Access Compliance Report

Public Rights-of-Way

Intersection ID: 9814	Main Street: CLIFTON_ST	Cross Street: PATTON_AV	Location: W
ADA ID: 3D1BB17393D8	Ramp Type: PerpDiag	Initial Pass/Fail: Fail	Overall Compliance: No
		Severity Score: 10

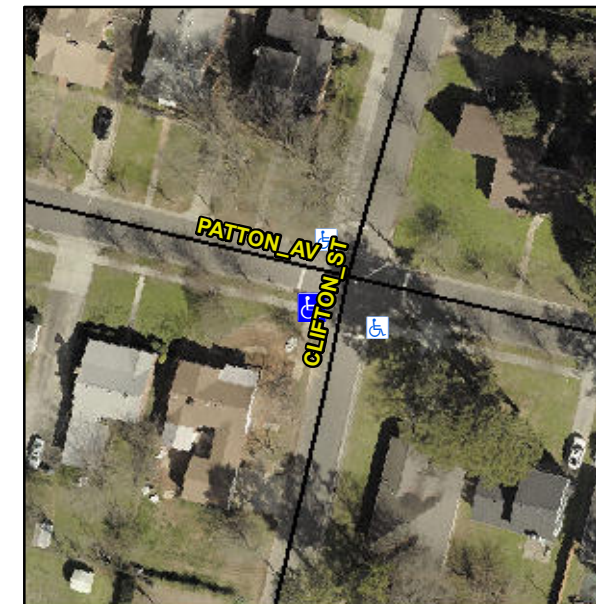
Not Found, R304.5.1, R304.5.3

Compliance	Description	Data	Compliance	Description	Data
N/A	Ramp Length (in)	48.5	Yes	Ramp Slope (%)	7.3
No	Ramp Width (in)	47.0	No	Ramp XSlope (%)	3.3
N/A	Flare Type LT	N/A	N/A	Flare Type RT	N/A
N/A	Flare Slope LT (%)	N/A	N/A	Flare Slope RT (%)	N/A
N/A	Flare Traversable LT?	N/A	N/A	Flare Traversable RT?	N/A
N/A	Landing Length (in)	N/A	N/A	DWS Provided?	N/A
N/A	Landing Width (in)	N/A	N/A	DWS Contrast?	N/A
N/A	Landing Slope (%)	N/A	N/A	DWS Length (in)	N/A
N/A	Landing X Slope (%)	N/A	N/A	DWS Full Width?	N/A
N/A	Landing Curb? (Y/N)	N/A	N/A	DWS Offset (in)	N/A
N/A	Shared Landing?	N/A			
N/A	Gutter Ponding?	N/A	N/A	Gutter Slope (%)	N/A
N/A	Gutter Lip Ht (in)	N/A	N/A	Gutter X Slope (%)	N/A
N/A	Painted X Walk1?	No	N/A	Painted X Walk2?	No
	X Walk 1 Direction	To SE		X Walk 2 Direction	To NE
N/A	X Walk 1 Width (in)	N/A	N/A	X Walk 2 Width (in)	N/A
	X Walk 1 Slope (%)	0.3		X Walk 2 Slope (%)	4.6
	X Walk 1 X Slope (%)	2.9		X Walk 2 X Slope (%)	0.8

Remove & Replace Curb Ramp With Two New Directional Ramps or Equivalent.
